Project	IEEE 802.20 Working Group on Mobile Broadband Wireless Access < http://grouper.ieee.org/groups/802/20/ >	
Title	LG Electronics Components Proposal for 802.20 MBWA	
Date Submitted	2007-03-07	
Source(s)	Young C. Yoon LG Electronics Mobile Research 10225 Willow Creek Rd. San Diego, CA 92131	Voice: 858-805-6555 Fax: Email: ychoon@lge.com
Re:	MBWA Call for Proposals	
Abstract	This contribution describes a number of component proposals for a Mobile Broadband Wireless Access (MBWA) system – referencing the current draft proposal.	
Purpose	For consideration and adoption into the 802.20 MBWA standard.	
Notice	This document has been prepared to assist the IEEE 802.20 Working Group. It is offered as a basis for discussion and is not binding on the contributing individual(s) or organization(s). The material in this document is subject to change in form and content after further study. The contributor(s) reserve(s) the right to add, amend or withdraw material contained herein.

LGE 802.20 Components Proposal

LG Electronics
March 7, 2007

RL Frame Design Enhancement during Silence Periods 1/2

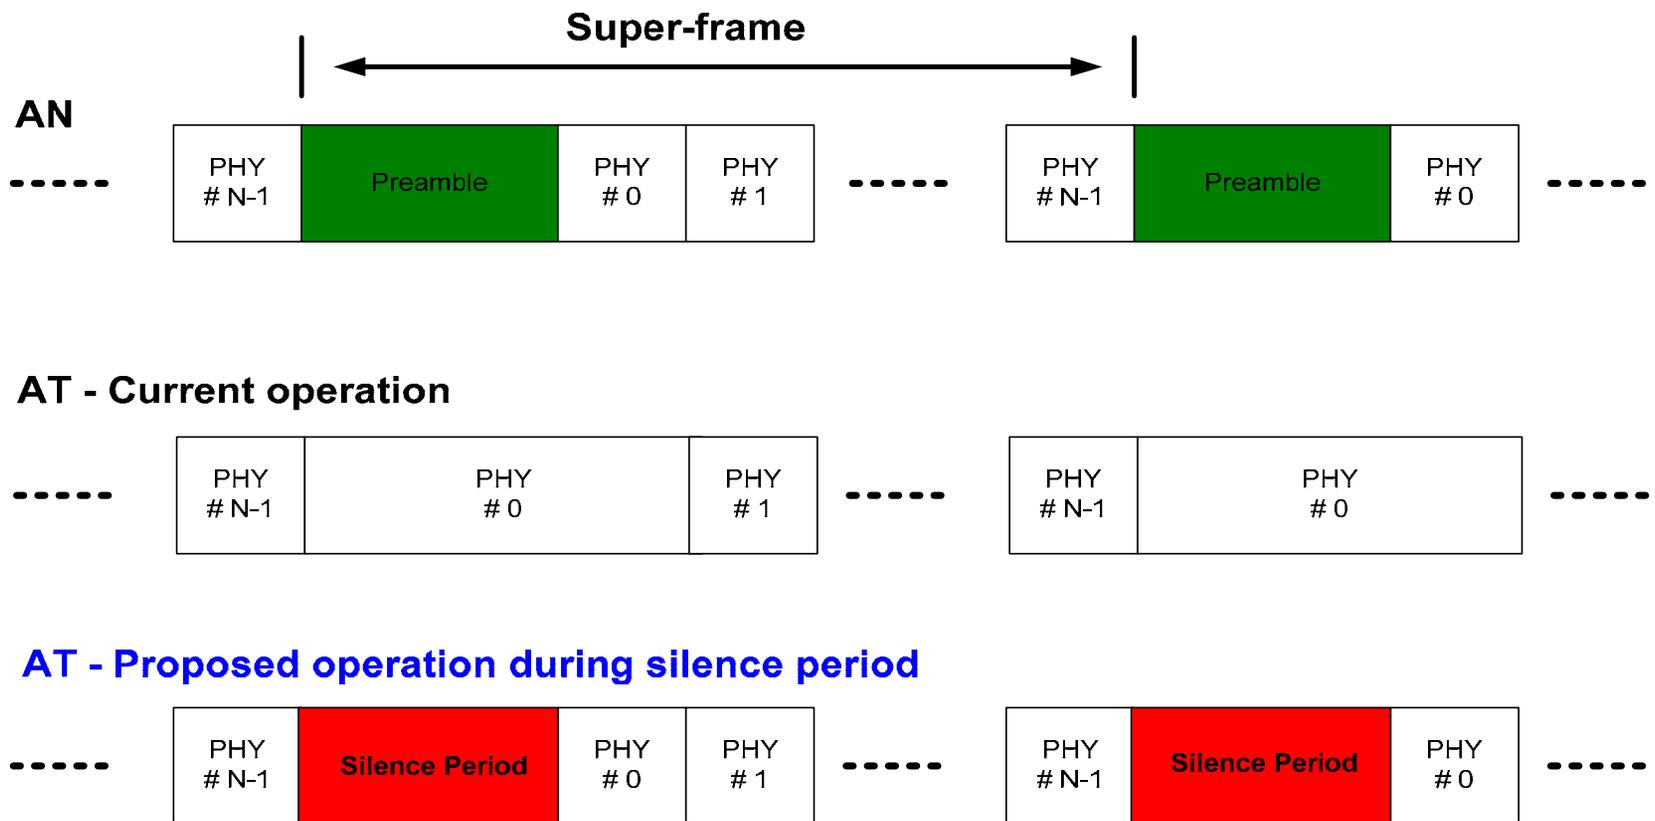
- We propose an enhancement to the RL frame design during the silence period
 - » Specifically, the design of RL PHY Frame #0
- Relates to:
 - » Section 7.1.3 “Superframe timing”
 - » Section 7.7.6.5 “Reverse link silence interval”
 - » Could be added into both sections

- Currently, RL PHY frame #0 is elongated for alignment w/:
 - » the FL preamble and FL PHY frame #0 [2, p. 19]
- We propose changing the RL PHY frame #0 design during silence periods
 - » Instead of the elongated RL PHY frame #0, use the regular sized RL PHY frame for frame #0 – aligned w/ FL PHY frame #0.
 - » The remaining unused portion can be used for the silence period
- Periodicity is in SilenceIntervalPeriod
